Metro Outer Joint Development Assessment Panel Agenda

Meeting Date and Time: Friday, 7 May 2021; 9:30am
Meeting Number: MOJDAP/84
Meeting Venue: City of Rockingham
Civic Boulevard, Rockingham

Development Description: Mixed commercial development
Applicant: Planning Solutions
Owner: Peet Golden Bay
Housing Authority
Responsible Authority: City of Rockingham
DAP File No: DAP/21/01952

**LOT 265 TALISKER BEND, GOLDEN BAY
DEVELOPMENT APPLICATION – PROPOSED MIXED COMMERCIAL DEVELOPMENT
RESPONSE TO REQUESTS FOR FURTHER INFORMATION**

5 711 - 10m PYLON - FRONT ELEVATION
1 : 25

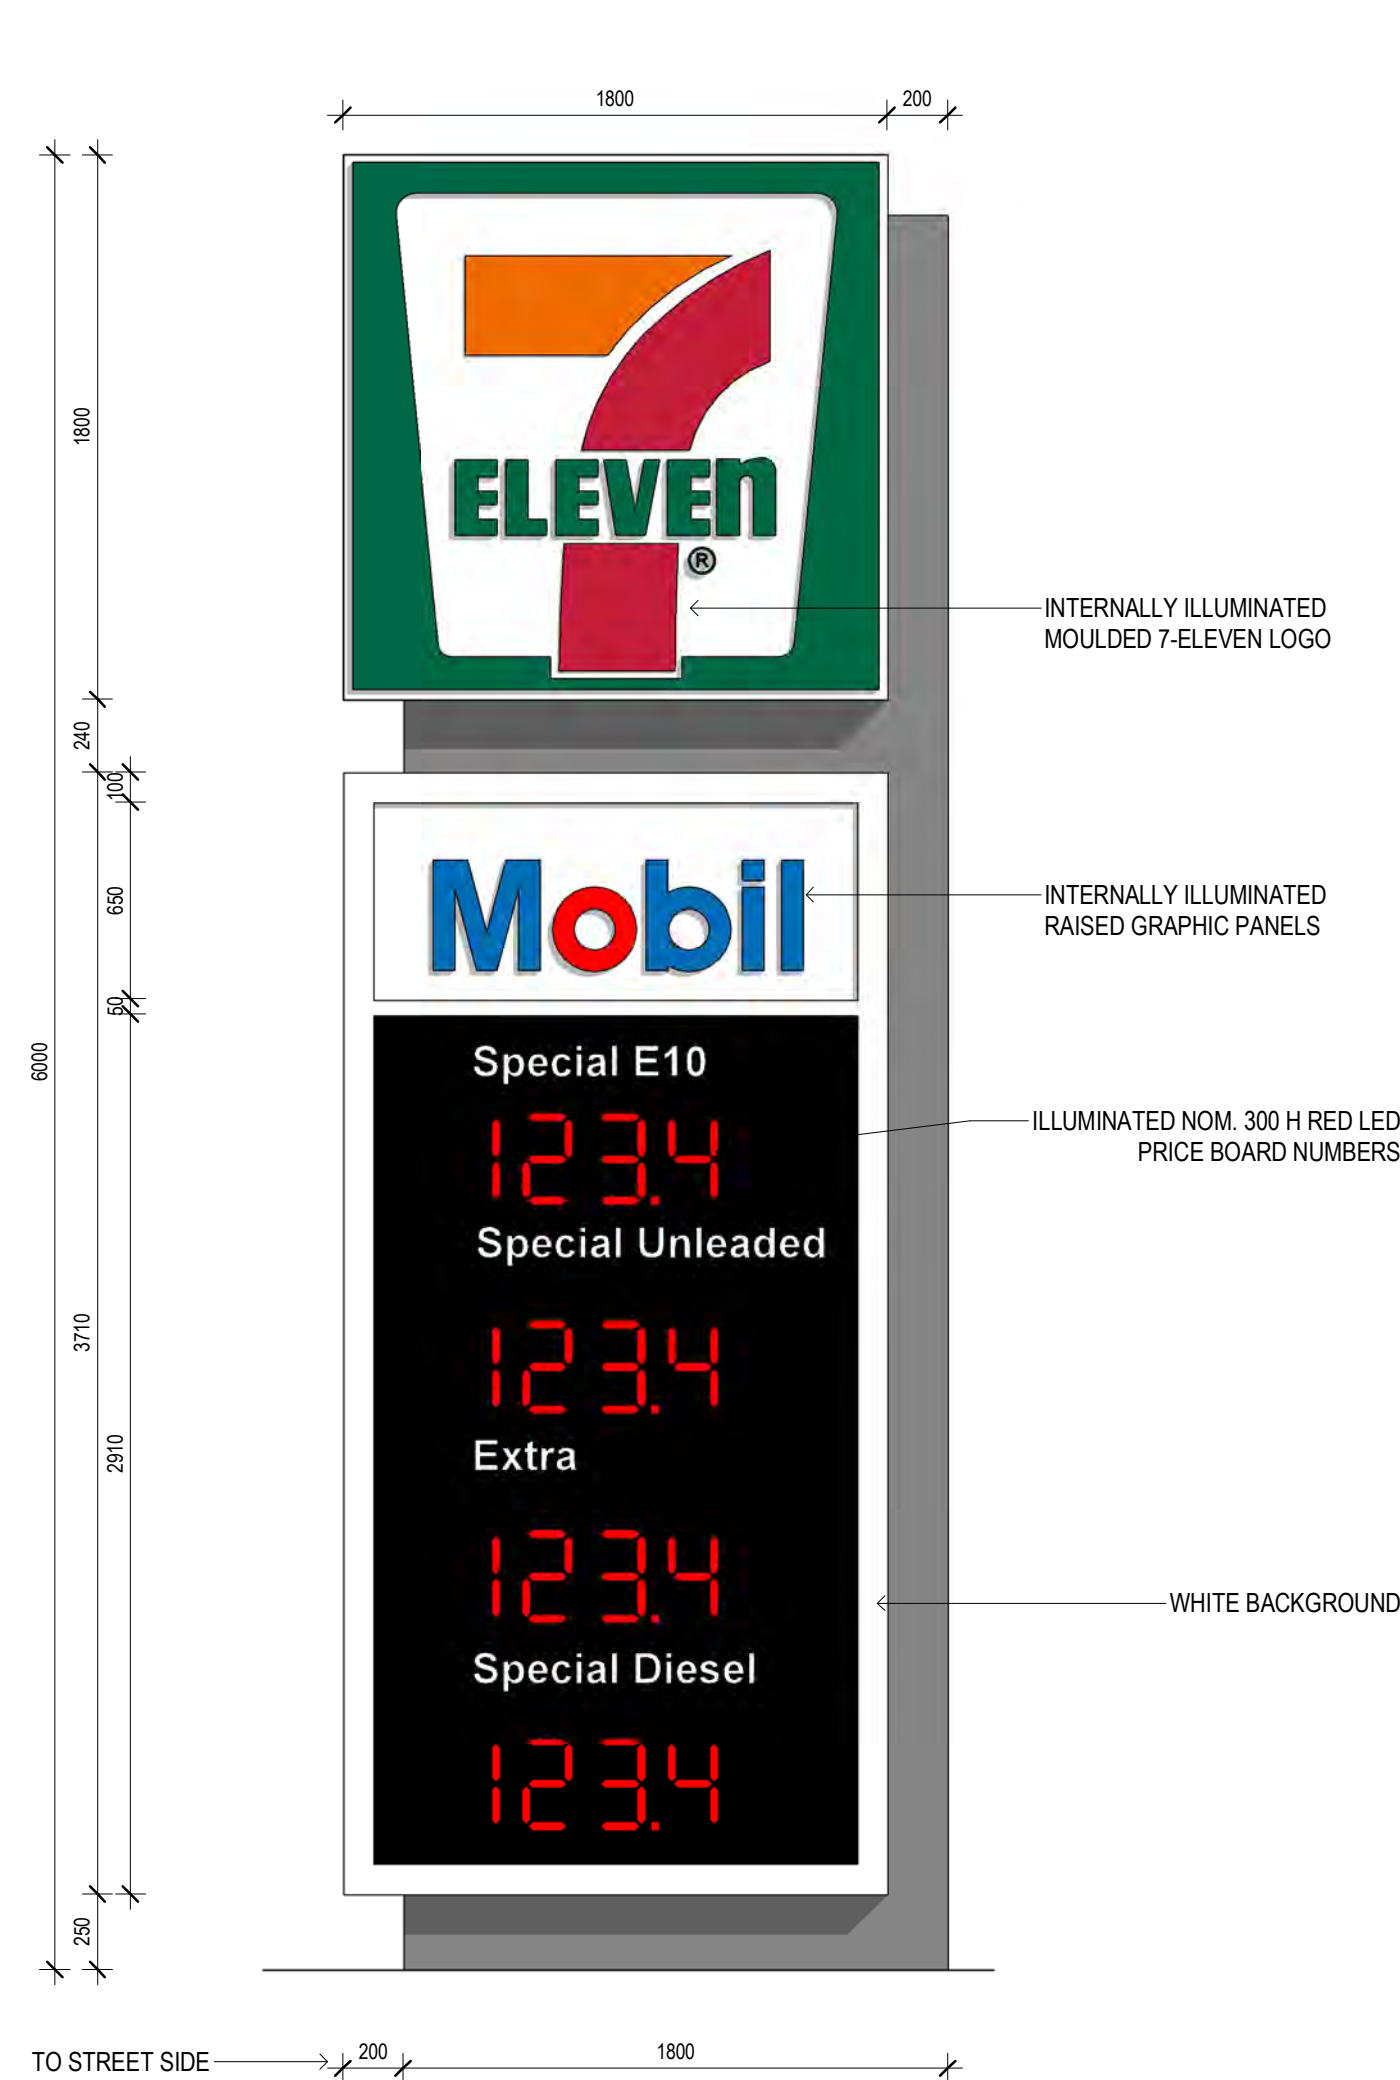
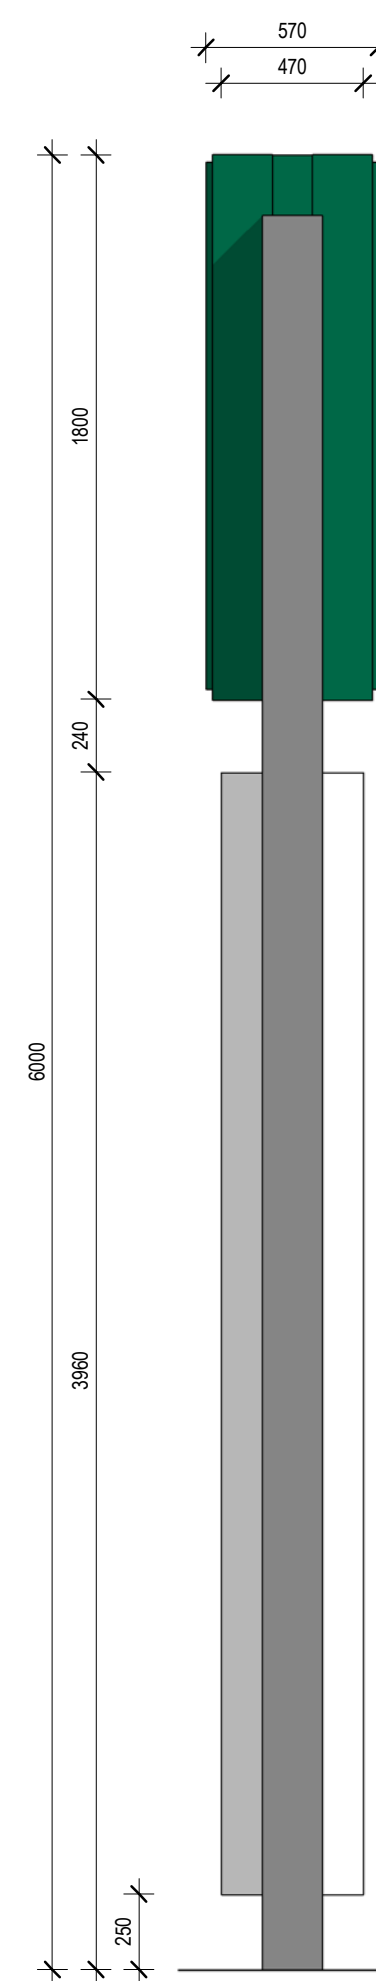
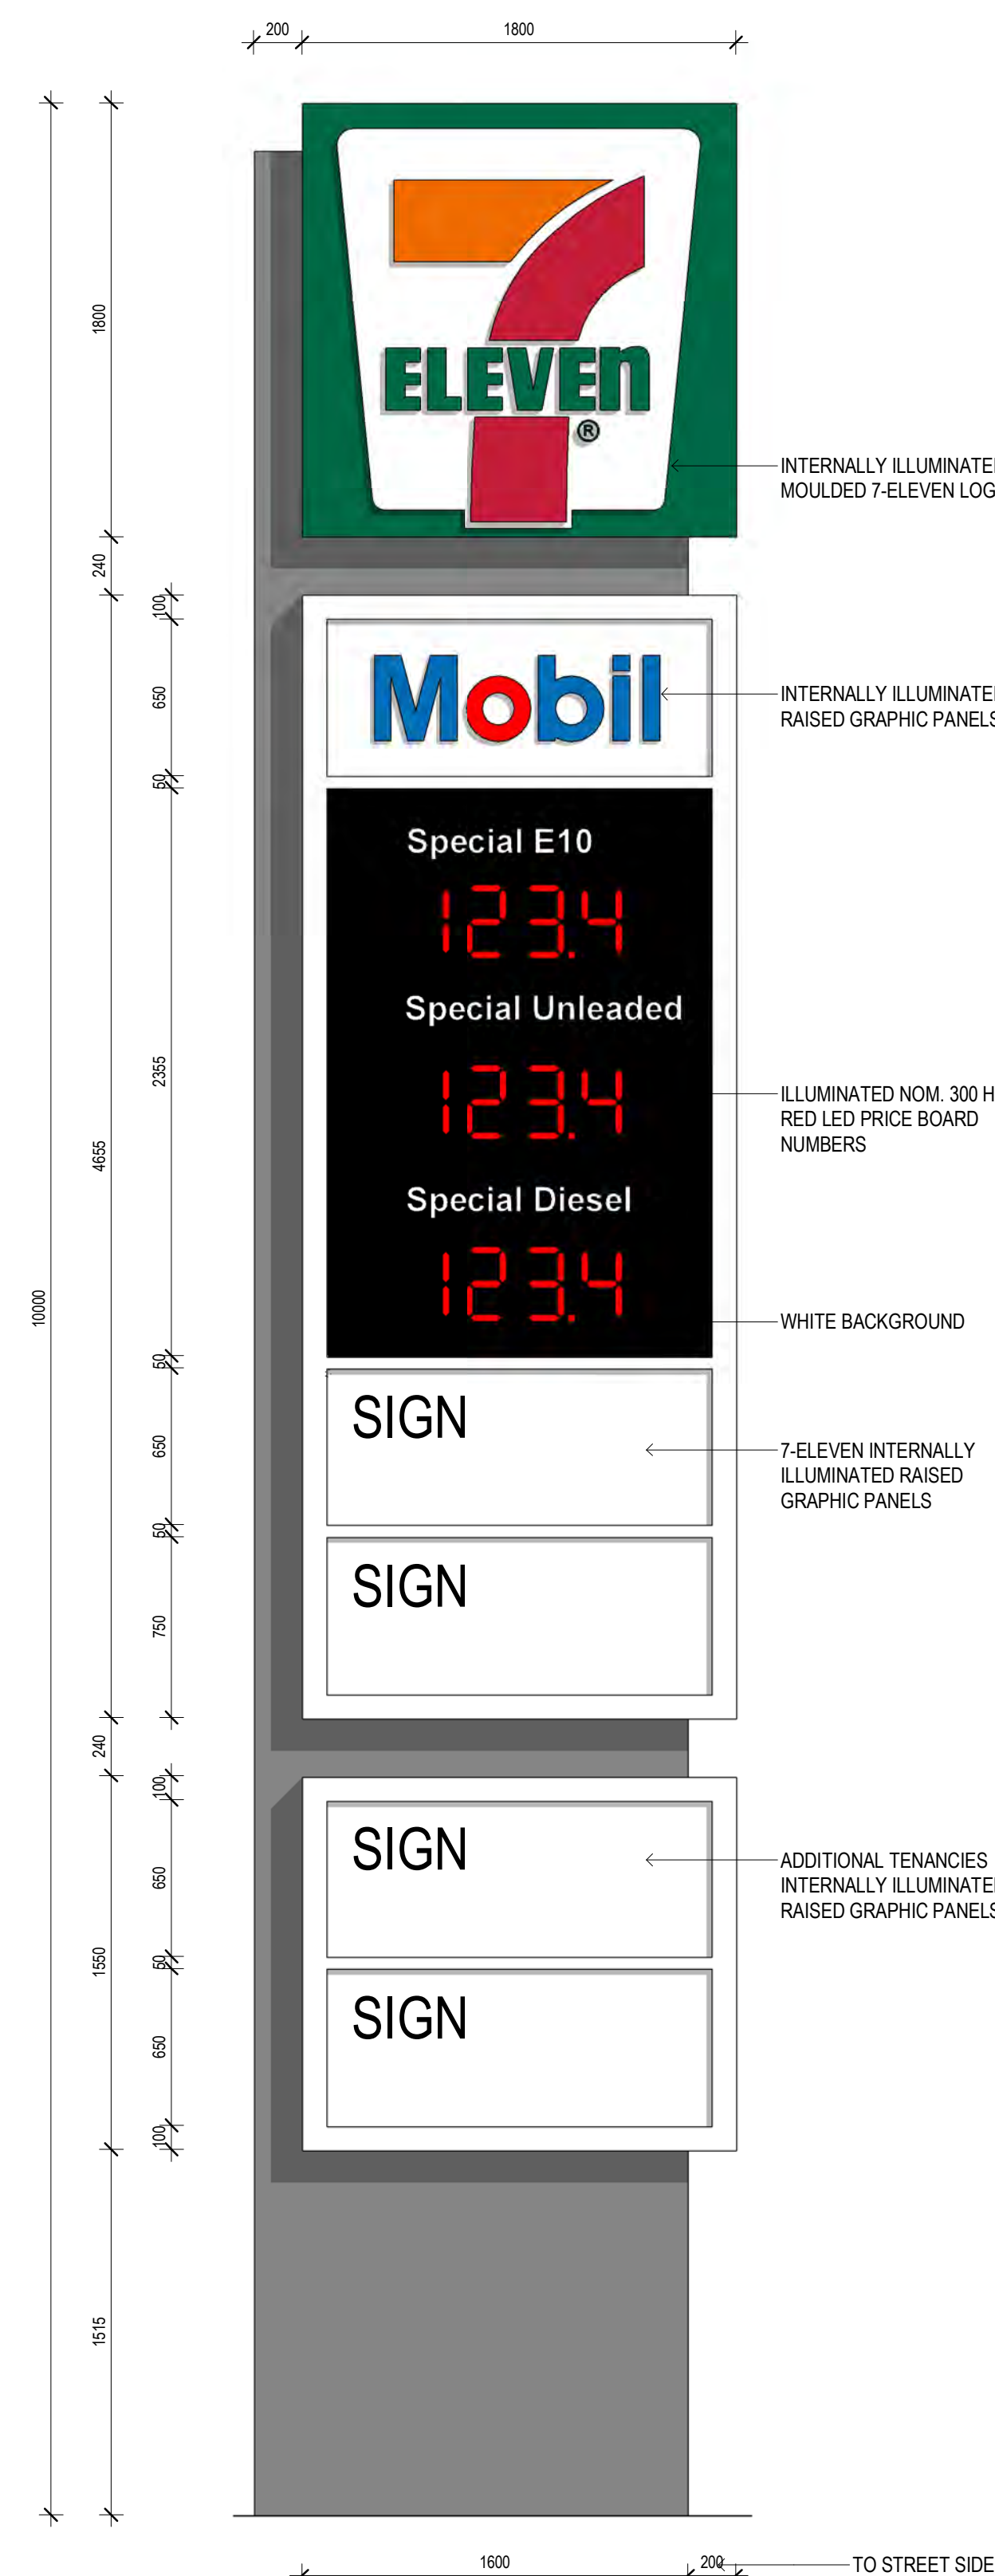
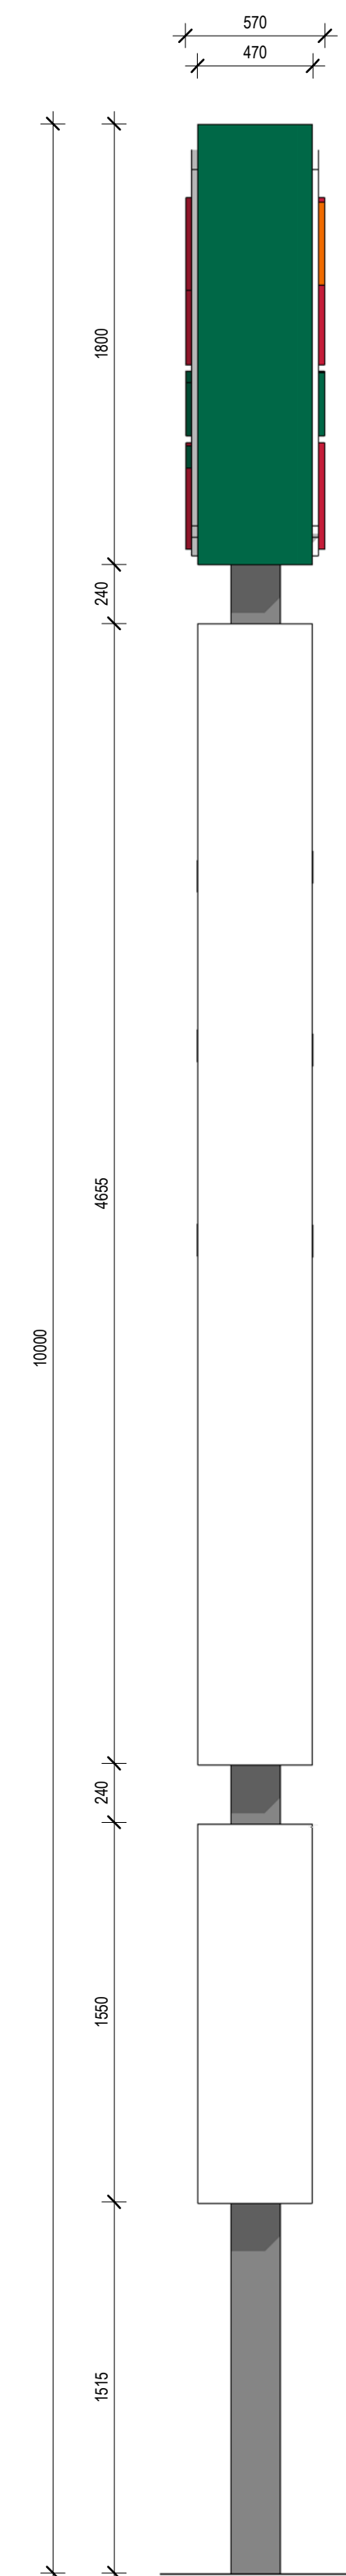
Pylon Sign must:	Officer Comment	Compliance - 10m high Pylon Sign	Compliance - 6m high Pylon Sign
(a) shall not be located within 1.8m of a lot boundary.	The 10m high pylon sign associated with the multiple tenancies is setback approximately 800m from Warnbro Sound Avenue road reserve and results in removal of an established tree. The 6m high pylon sign associated with the fuel retailing building has a Nil setback from the Thundelarra Drive road reserve.	No	No

(d) have a height exceeding 6.0m, unless it can be demonstrated to the Council that a greater height is warranted and it complies with the objectives of this Planning Policy. In any event, a Pylon Sign shall not exceed 9.0m in height.	A 10m height above natural ground level is proposed for the multiple tenancies pylon sign, whilst a 6m height above natural ground level is proposed for the fuel retailing building pylon sign.	No	Yes

In light of the above, two pylon signs can be supported on this development site subject to a height and relocation modification of the 10m high multiple tenancies pylon sign.
